WOODLAND PARK PLANNING COMMISSION REGULAR MEETING & WORK SESSION AGENDA 7:00 PM – JULY 23, 2020 CITY HALL COUNCIL CHAMBERS (220 W. SOUTH AVENUE) & VIA ZOOM (through address on City website)

Staff Report - Planning Commission

SUB2020-02 & SPR 2020-03: Request for a Preliminary Plat and Site Plan Review from Brecken Heights, LLC (Mark McNab) and Quaking Aspens, LLC (Gary Edmonds) to develop a 32-unit multi-family residential project (16 duplexes) including public and private open space, and a public right of way located at 19569 E. US Highway 24 (13.09 acre tract in the NE4 SW4- Section 30, T12S-R68-W6th PM) in the Multi-Family Residential Suburban (MFS) and Community Commercial (CC) zone district.

BRECKEN HEIGHTS LOT AND TRACT EXHIBIT

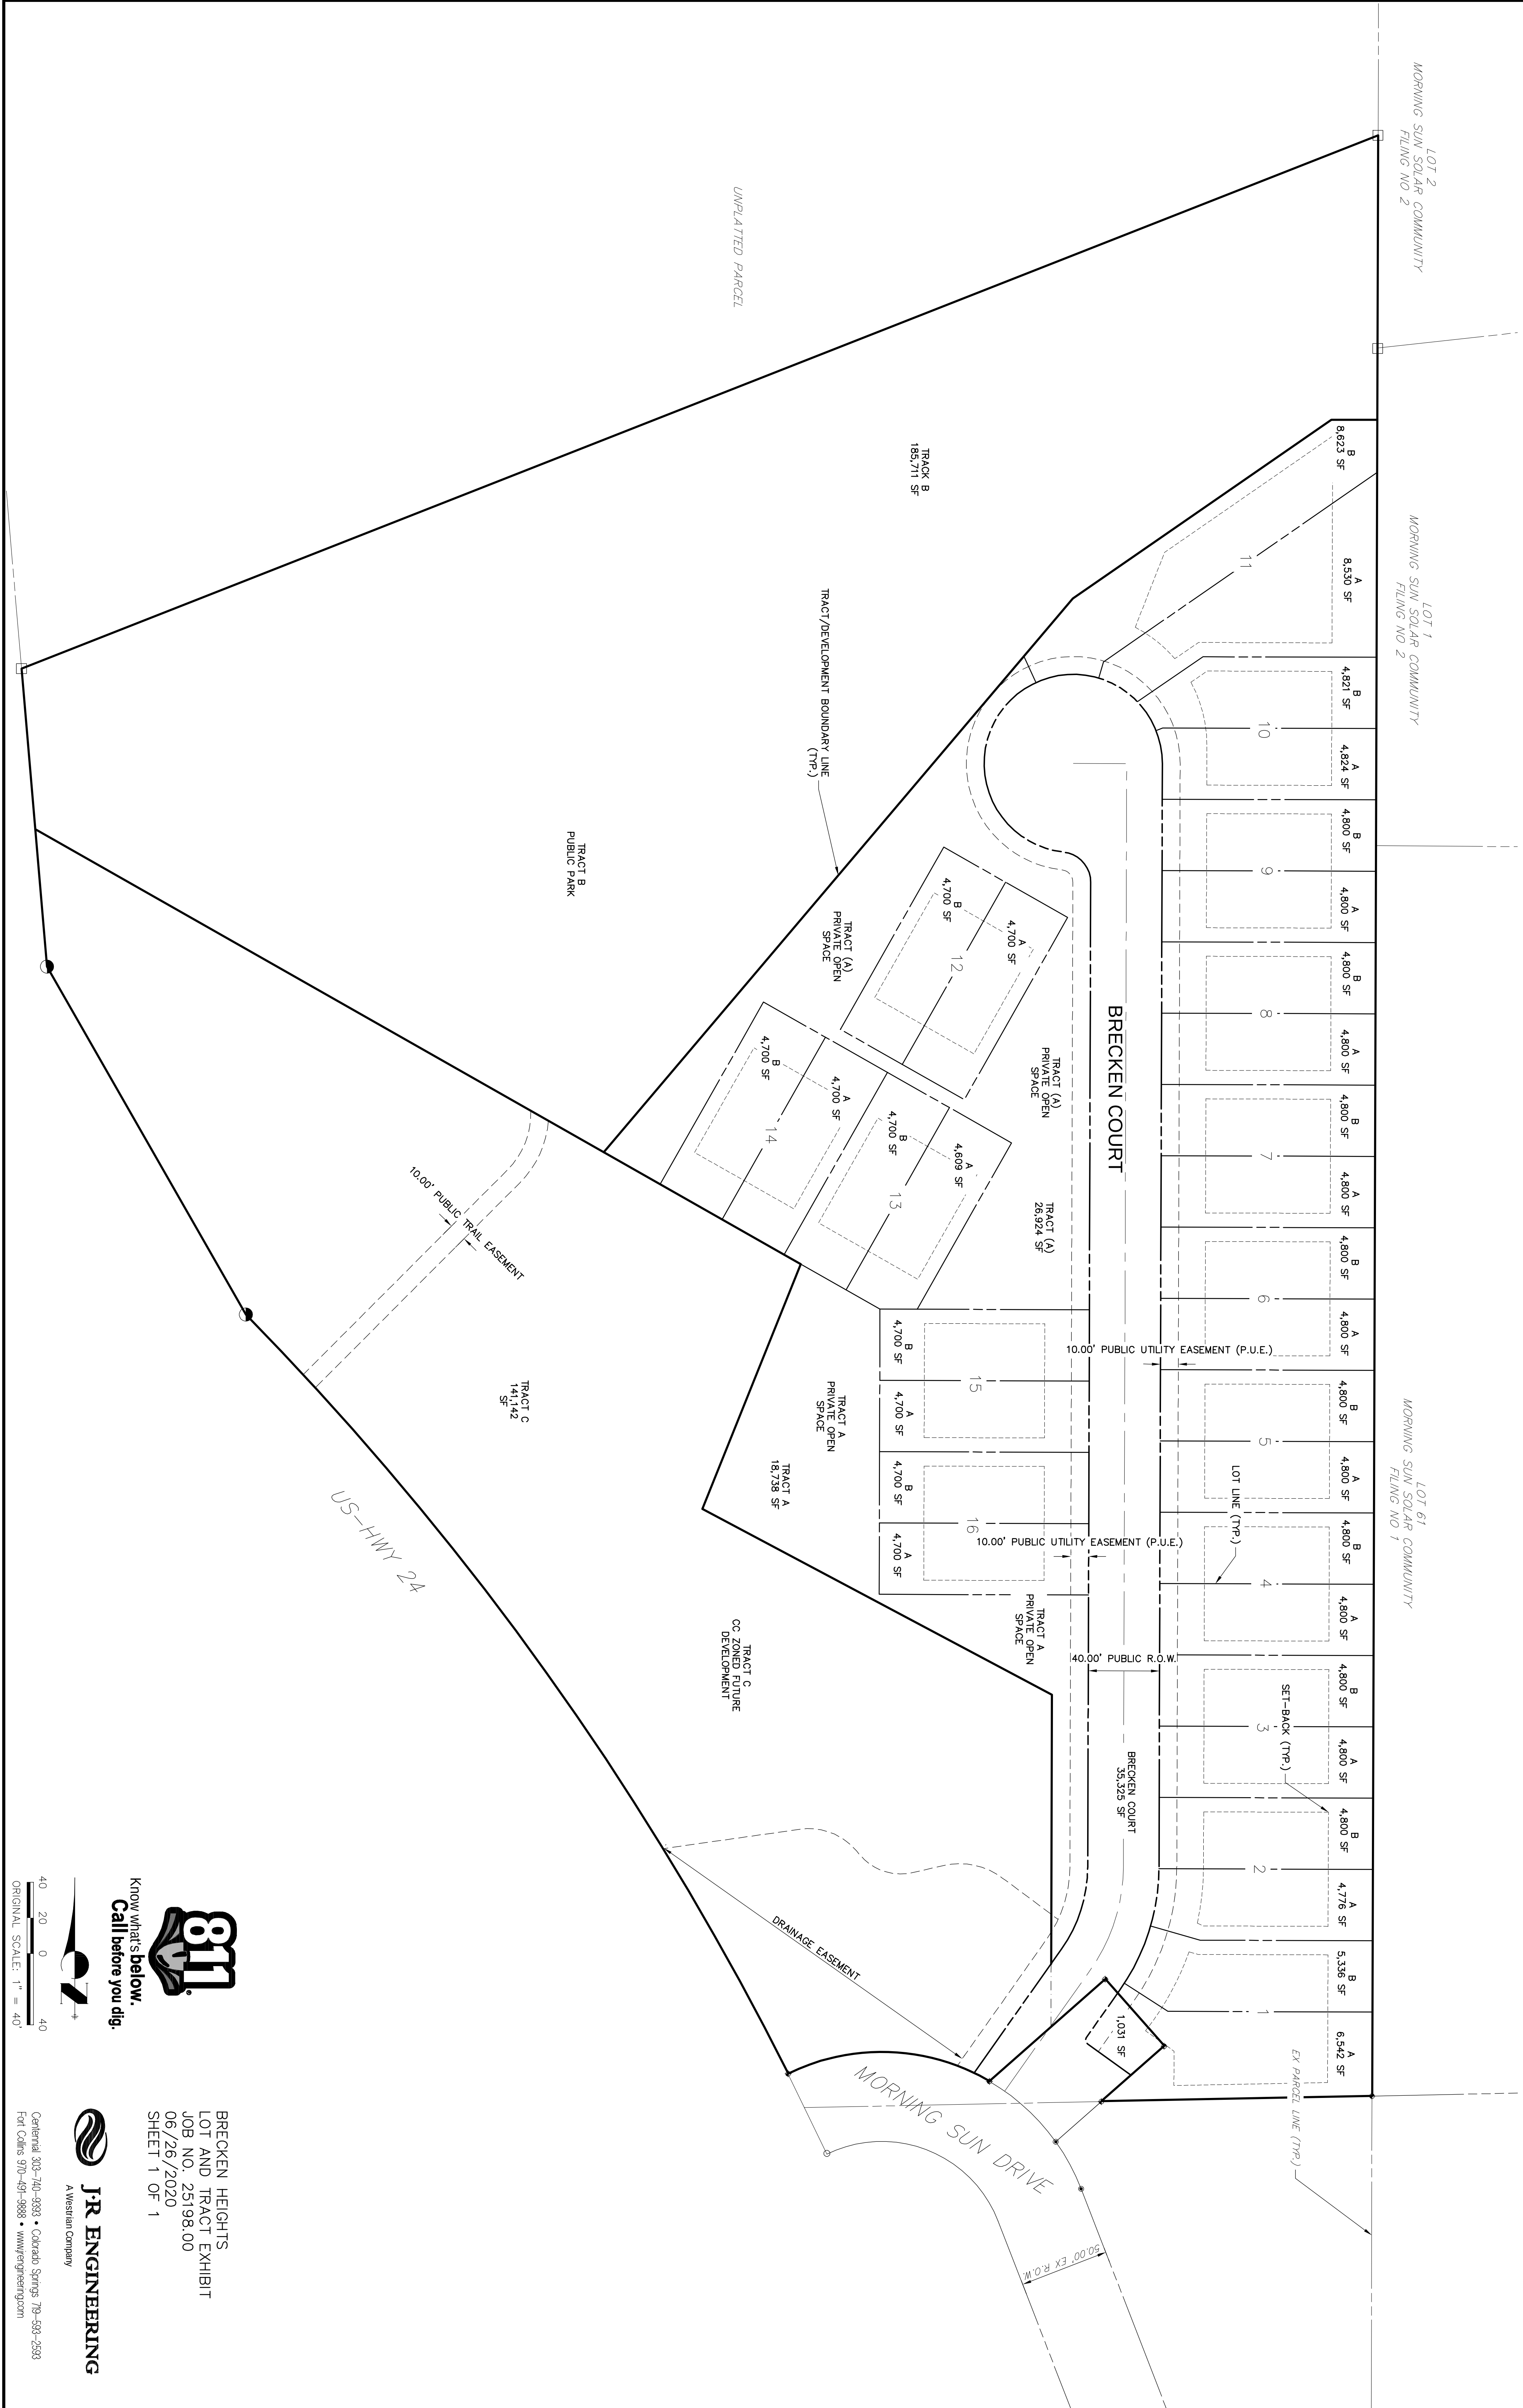
The Preliminary Plat proposes several private open space tracts that will be owned and maintained by the Homeowners Association. The Parks & Recreation Advisory Board reviewed the preliminary plat on July 8, 2020 and recommended that the City accept the park land dedication (consisting of 185,711 SF within Tract B complete

with the 10 foot wide trail easement through the north part of Tract C) and have no objection to the gravel trail surface (breeze material), 8 foot trail width, and picnic tables as shown on the preliminary plat.

2. The first final plat to be considered shall include:
 - a. A dedication statement for the 10 foot wide public trail easement in Tract C;
 - b. A dedication statement for the Brecken Court;

- c. A dedication statement for the public park (Tract B);
 - d. A draft of the covenants for the subdivision, including the establishment of a Homeowner's Association;

PRELIMINARY PLAT/SITE PLAN
BRECKEN HEIGHTS
JOB NO. 25198.00
06/22/20
SHEET 2 OF 12

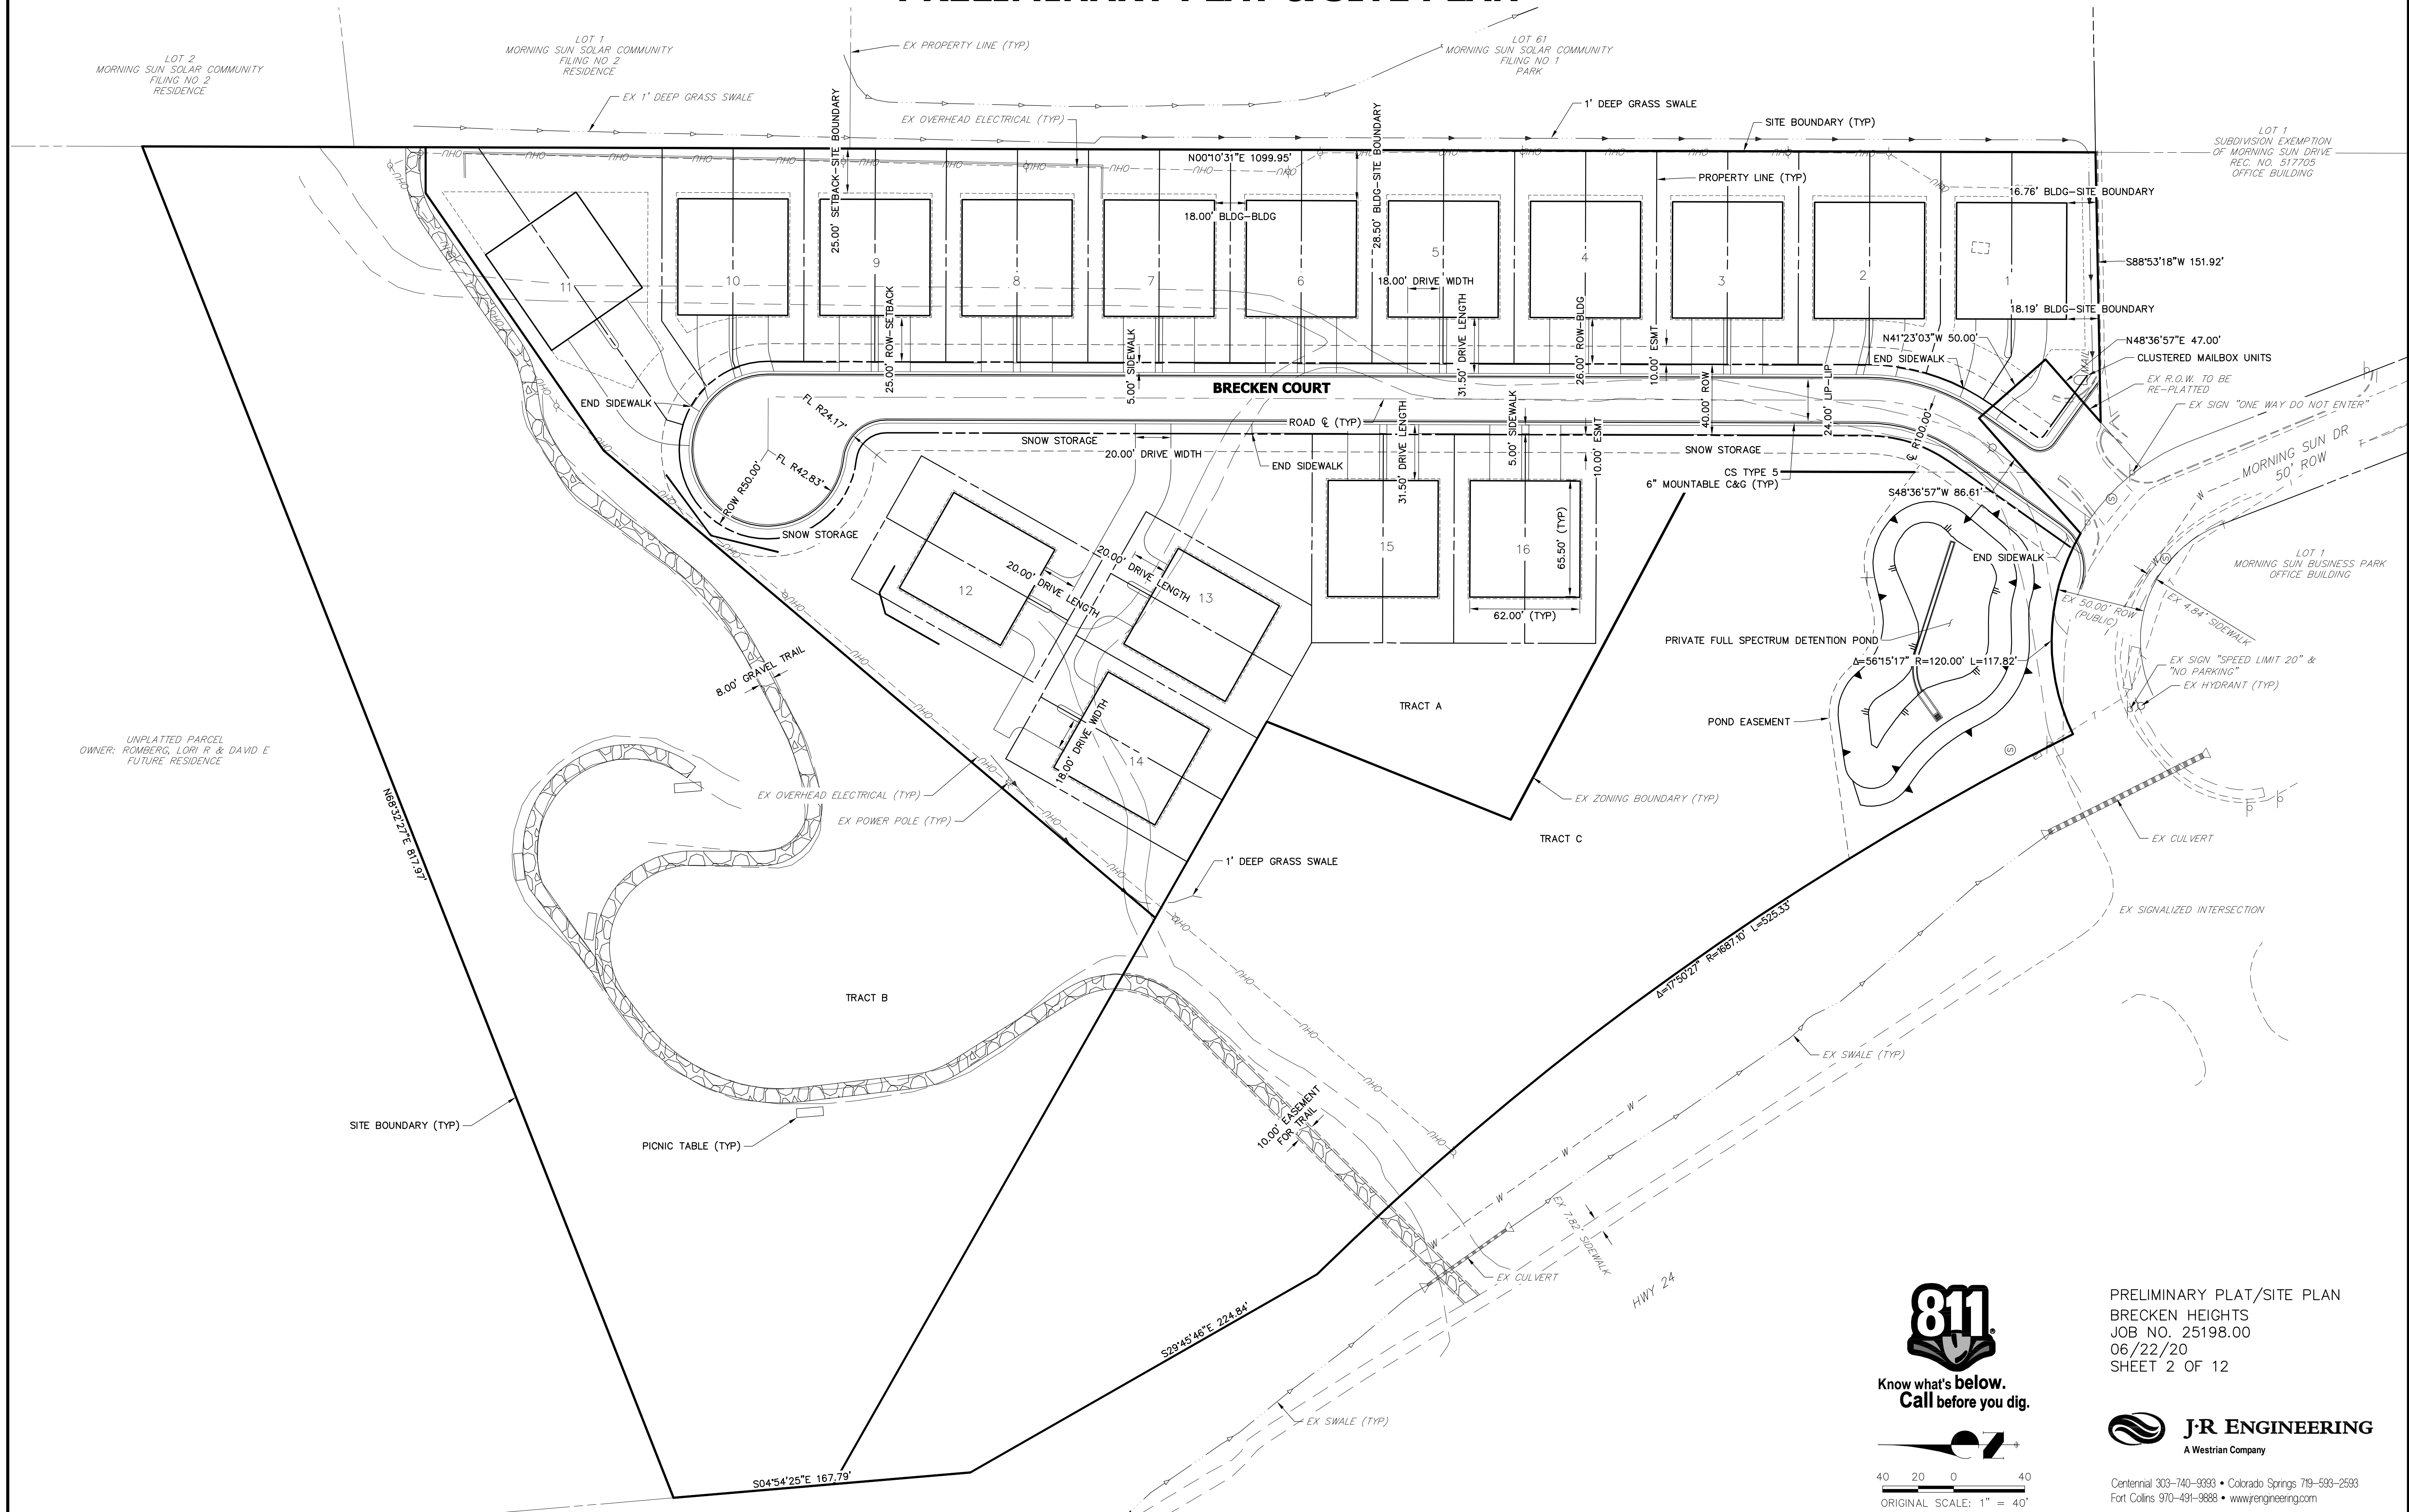
The preliminary plat as proposed does require variances from the following subdivision regulations: (1) a 10' variance of §17.40.140 which requires a 50' minimum width for local road right-of-ways (ROW) with curb and gutter ROW and (2) a variance of §17.40.220 to reduce the required lot frontage from 40 feet for Lot 1B, 2A, 10B, 11A&B, 12-14A&B. The proposal shows a 40' wide ROW with a 10 foot wide public utility easement on both sides resulting in an adequate 60 foot wide area of land for roads and utilities. Further the applicant shows available and adequate access to each lot even though the frontage may be less than 40 feet (Lot 1B, 2A, 10B, 11A&B) or the access is from a private drive easement (Lots 12-14). Staff does not object to either of these variances as access and utilities are available to each lot.

- a. A 10 foot variance from MC §17.40.140 (from 50 feet to 40 feet for the minimum width of a local road ROW complete with curb and gutter); and
 - b. a variance of MC §17.40.220 (from 40 feet of lot frontage to some number less than 40 feet (as depicted on the preliminary plat) for Lot 1B, 2A, 10B, 11A&B, 12-14A&B.
